WCAP-15689-NP  
Revision 1

September 2002

# **Evaluation of Transit-Time and Cross-Correlation Ultrasonic Flow Measurement Experience with Nuclear Plant Feedwater Flow Measurement**

Figure 2  
Difference in Flow Profile Factor Between Vertical and Horizontal Oriented Transducers Downstream of Elbow for  
CROSSFLOW and Transit time meter

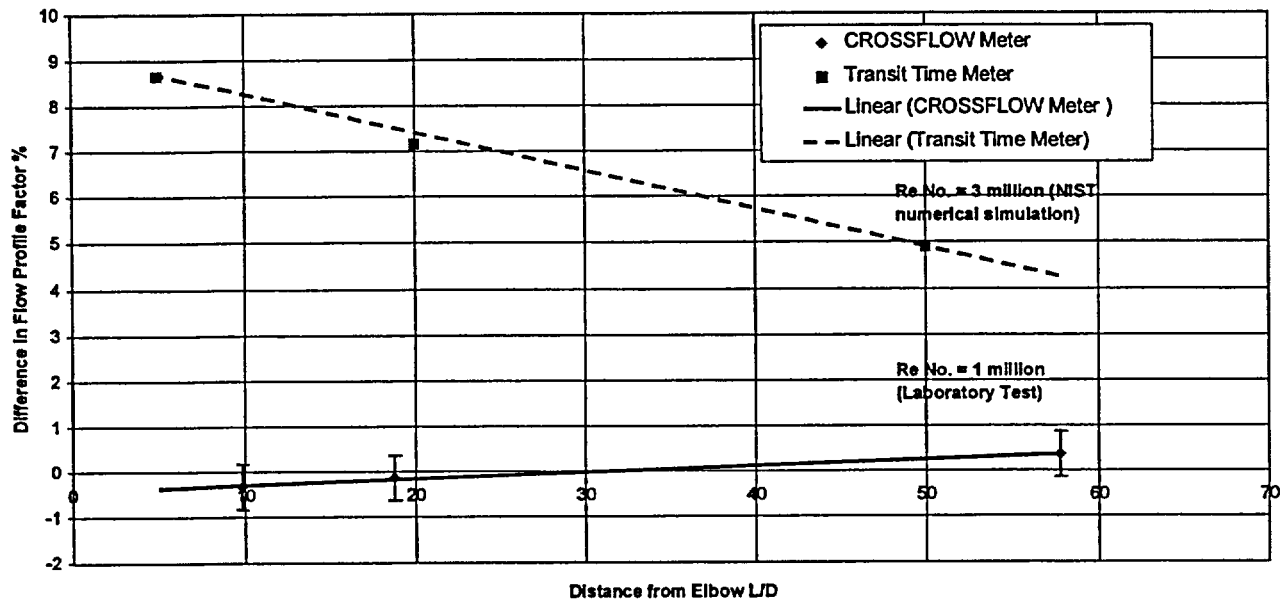
With respect to WCAP-15689-NP, Page 6, Section 2.4, 2<sup>nd</sup> paragraph and Figure 2:

This figure is marked proprietary in its entirety, however, the corresponding discussion of the figure is non-proprietary. Please provide a non-proprietary version of the figure, if possible, to facilitate writing of the NRC's ER-262 evaluation report which will be in the public domain. Additionally, the lines drawn on the figure are indistinguishable from one another since the figure is not in color. Use of different line types would facilitate understanding the figural presentation.

The proprietary classification of Figure 2 has been removed so that the figure can be referenced in the NRC evaluation report. To facilitate the presentation, the sensitivity curve for the transit-time meter has been replaced by a dashed line to delineate it from the corresponding curve for the CROSSFLOW meter. The revised figure is shown below and has been downgraded from its former proprietary status to facilitate NRC use.

Response of Clamp-on Transit-Time Meters and  
A Cross-Correlation Meter Due to Slightly Non-Fully Developed Flow Profile

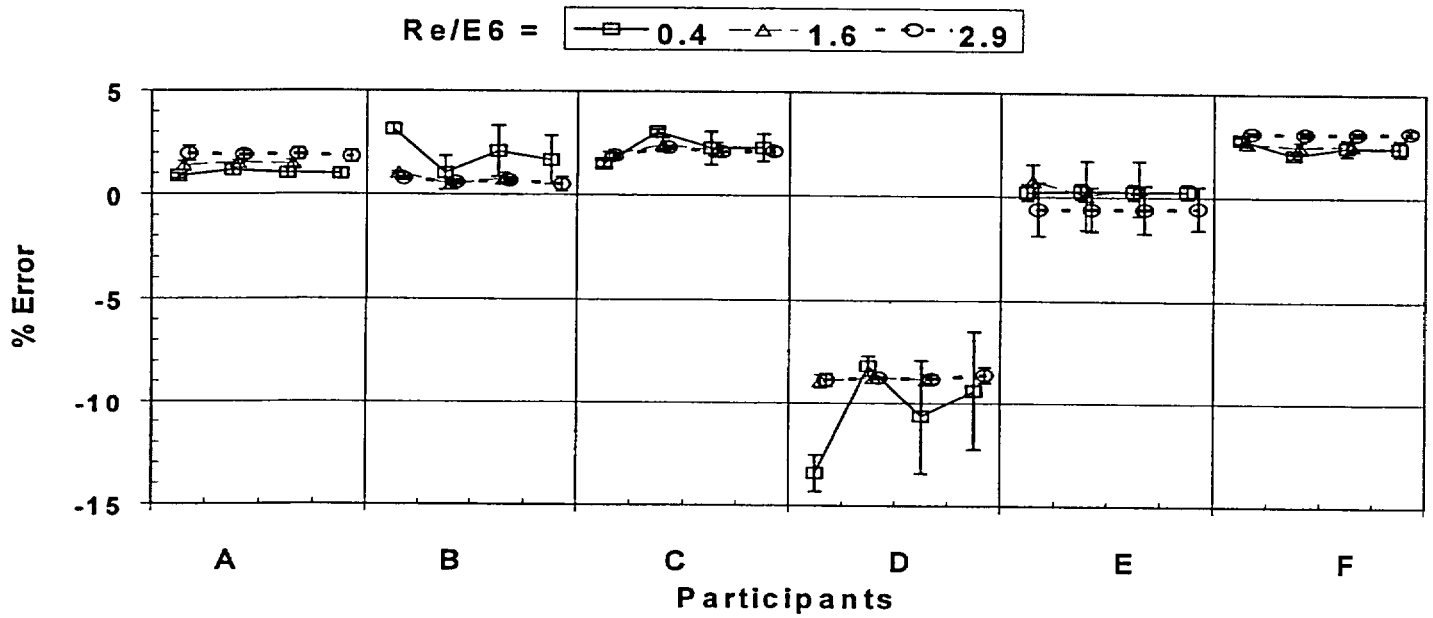
With respect to WCAP-15689-NP, Page 19, Figure 3, shows several gradations within the individual participants meter responses.

The gradations within the individual participant's responses are a demonstration of the meter's repeatability. For each meter, measurements were made for three (3) Reynolds numbers (shown as the vertical separations for each meter). The meter was then removed from the test section and then reinstalled on the pipe and another set of measurements taken. This process was repeated four (4) times as shown in Figure 3, leading to the four (4) gradations for each RE measurement (seen as the horizontal separations).
